# Work Order ID 88788

Item Name: Crosstube Turning Detail

<b>DART AEROSPACE LTD</b>	<b>Work Order:</b>	<b>28788</b>
<b>Description: Crosstube Assembly (412 High Aft)</b>	<b>Part Number:</b>	<b>D412-664-243</b>
<b>Inspection Dwg: D412-664-243 Rev: E</b>		<b>Page 1 of 2</b>

DRAWING NO. D412-664-243	TITLE CROSSTUBE ASSEMBLY (412 HI AFT)	REV. E	DART AEROSPACE LTD ENGINEERING ORDER		D.E.O. NO. D412-664-243-E-1	SHEET NO. SHEET 1 OF 2	SCALE NTS
DRAWN	CHECKED	MFG. APPR.	APPROVED		DE APPR.		
DATE 11.03.31	DATE 11/03/31	DATE 11.03.31	DATE 11/03/31		DATE 11-03-31

**D212-664-243**  
**ASSEMBLY DETAIL**

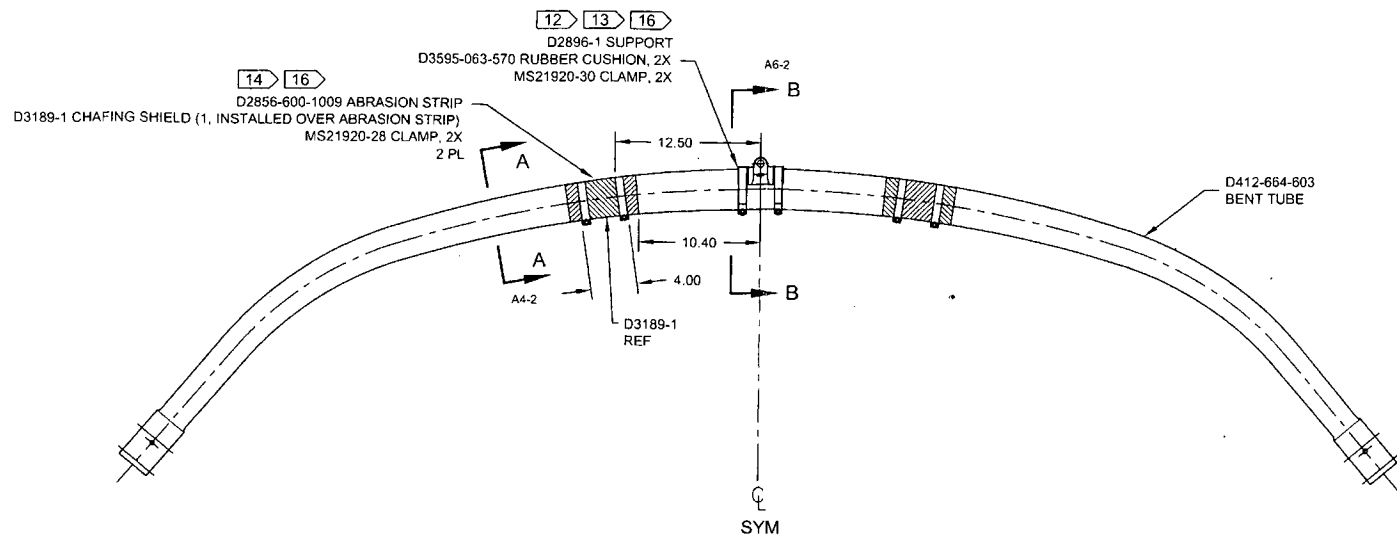
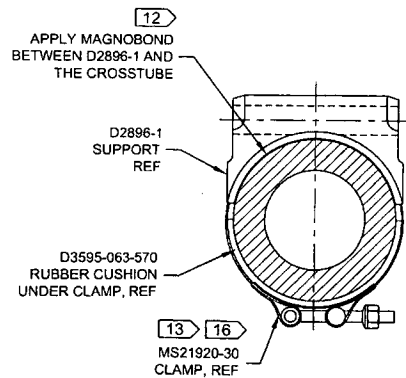
② DEO ATTACHED

**D412-664-243TRN**  
**TURNING DETAIL** E

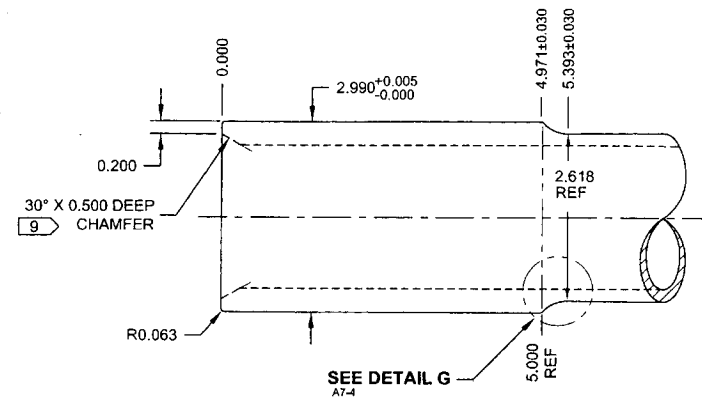
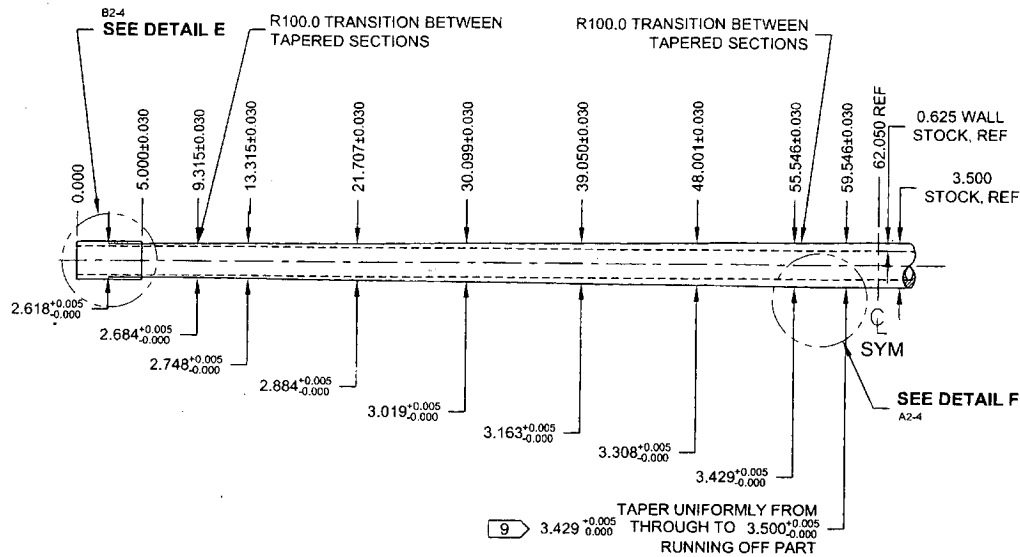
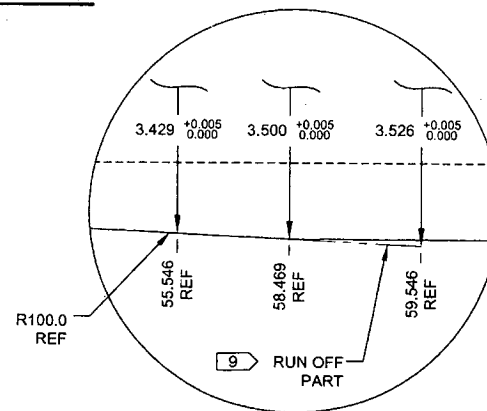
Root Cause	Date	Step	Qty	Description of work order update or Non-conformance	Initial Chief Eng	Action Description	Sign & Date	Verification	QC Inspector
Doc/Data									
Equip/Tooling	12/8/15	100	1	Both Cuffs are turned UNDER tolerance 2.988" - 2.984"	DAS 12 8-89	CP measures top to be in tolerance.	DAS 12 8-89	DAS 16 8-89	DAS 16 8-89
Operator									
Material									
Setup									
Other									
Process									
Supplier									
Training									
Unapproved
